## Certified Recommendation of the City of Raleigh Planning Commission

**Case File / Name:** MP-1-10 / 5401 North (revised)

**Nature of Case:** Master plan associated with the petition to rezone approximately 402 acres by adding the Planned Development Conditional Use Overlay District. This plan proposes a mix of land uses allocated among three tracts with a maximum of 2,250 residential units and 1,605,000 square feet total of non-residential space. Among the three tracts are six primary zones (“transects”) ranging from the highest mix of uses and residential density closer to Louisburg Road to the lowest intensity of use closer to the Neuse River. Each transect has unique character defined by street cross sections, building height and placement as well as allowable mixed land uses. The applicant proposes that this master plan will create a pedestrian-oriented mixed-use development of urban character.

## Staff Report

### Master Plan Map Showing Transect Zones and Street Layout

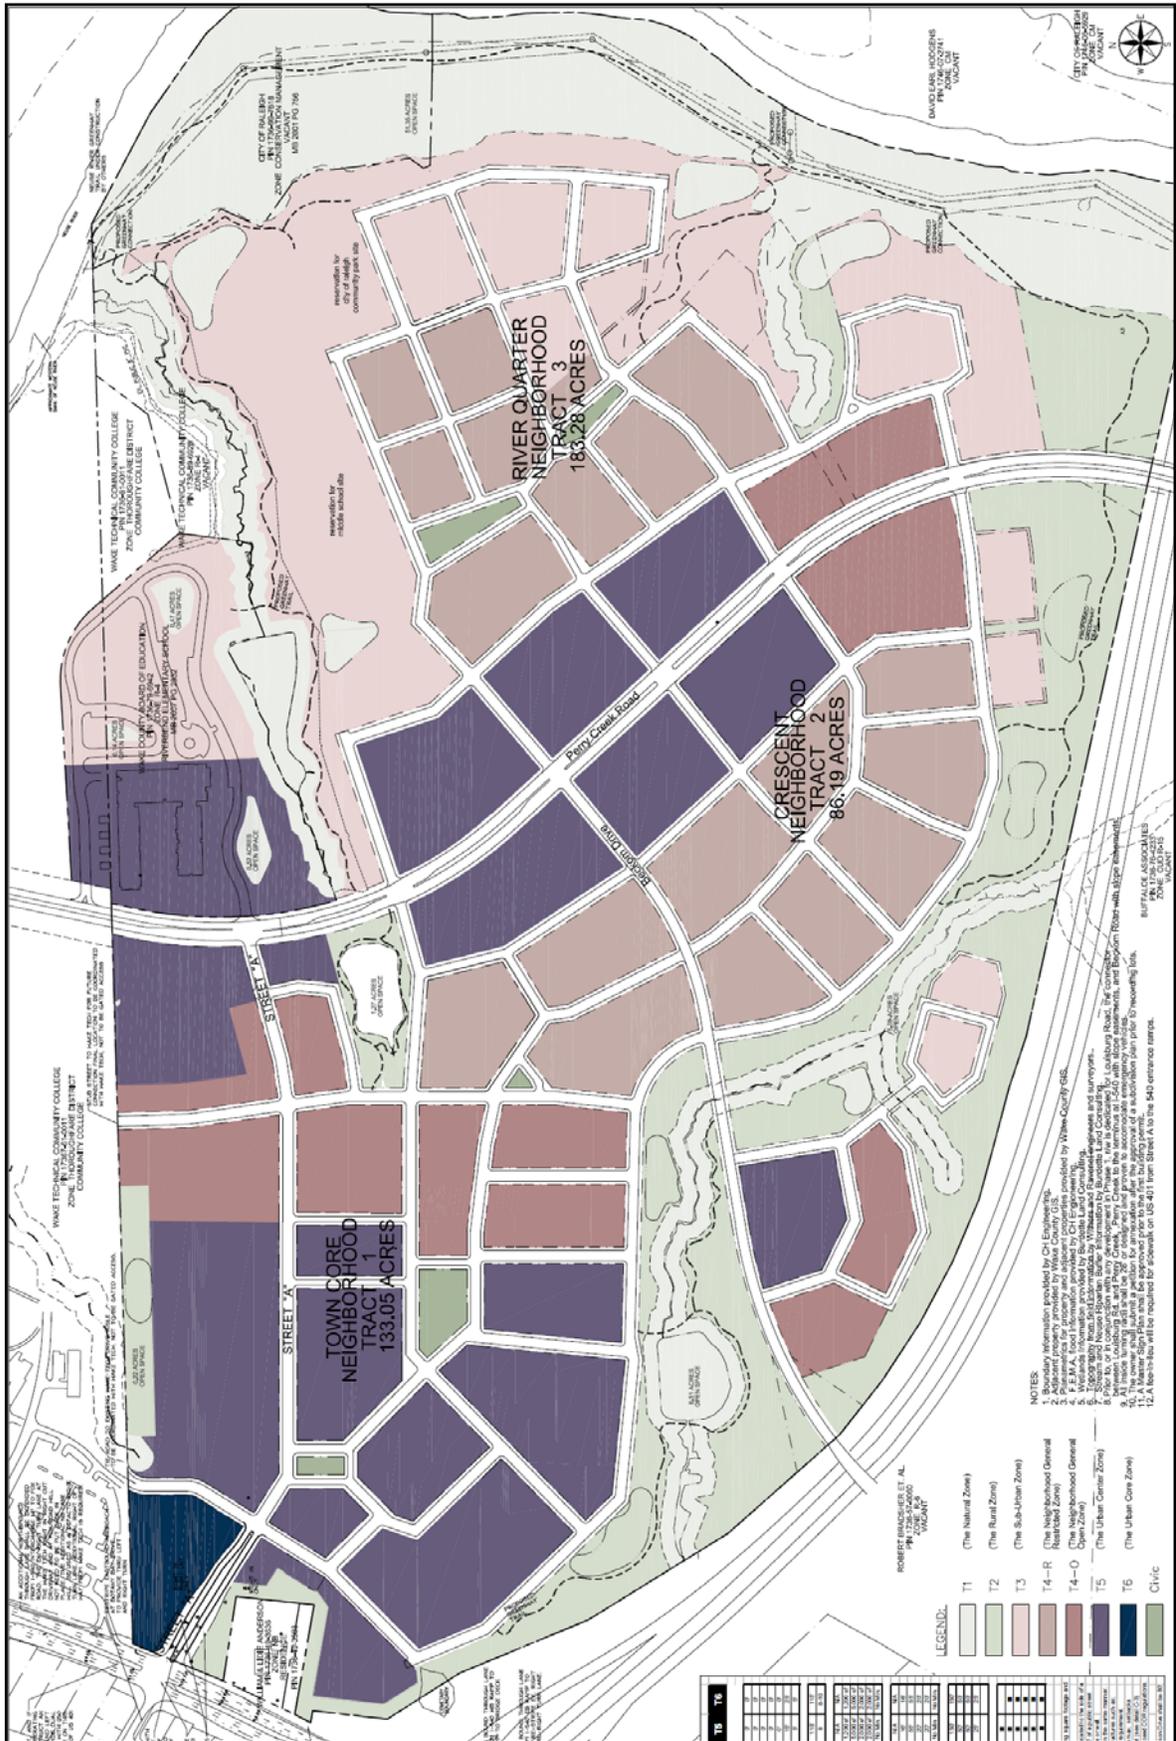
- Establishment of unique building setback, height, lot size, and lot dimension standards within the development.
- Establishment of special building setbacks along the site’s perimeter adjacent Louisburg Road and I-540, the Neuse River, Wake Technical Community College, and the current Anderson Property occupied with the historic Alpheus Jones House. Tree preservation and landscape buffer standards are also included for the area adjacent the Anderson Property.

- Allowance of additional retail space over 10% of gross land area. The proposal includes a request to allow up to 20% of the site to be dedicated to retail uses.

- Creation of 18 varying-width design standards for public and private streets.
- Proposed alternate landscape street protective yard designs associated with the various unique street cross-sections.

- Proposed alternate to landscaped transitional protective yard buffer width and planting requirements between differing land uses within the master plan area. In lieu of providing buffers within the planned development the developer will install street trees within landscaped street medians. In addition the plan limits the proximity of car wash facilities and bars from low density residential housing.

- Alternate screening of vehicular surface areas located within 50’ of public streets
- Alternate off-street parking requirements with allowable reduction of 45% within certain zones.

- Adoption of other urban design guidelines including limits on surface parking location and limits on maximum non-residential building size for single use tenants within a certain zone.

- Reservation of two areas for public acquisition and development of a middle school and park for a two year period.
- Creation of single family detached lots with net lot areas less than the underlying zoning districts. The applicant has prepared two exhibits showing how 11 factors contained in 10-2057(f)(1) | can be accommodated on the smallest residential lots.

- Provision of 16% open space totaling 65.6 acres (15% required).
- Creation of a master sign plan for the development. If the unified sign criteria utilize custom allowances for the Planned Development Overlay District then City Council approval is proposed.

- Concordance with Comprehensive Plan policies UD 2.6 and UD 7.3(b), relating to structured parking.
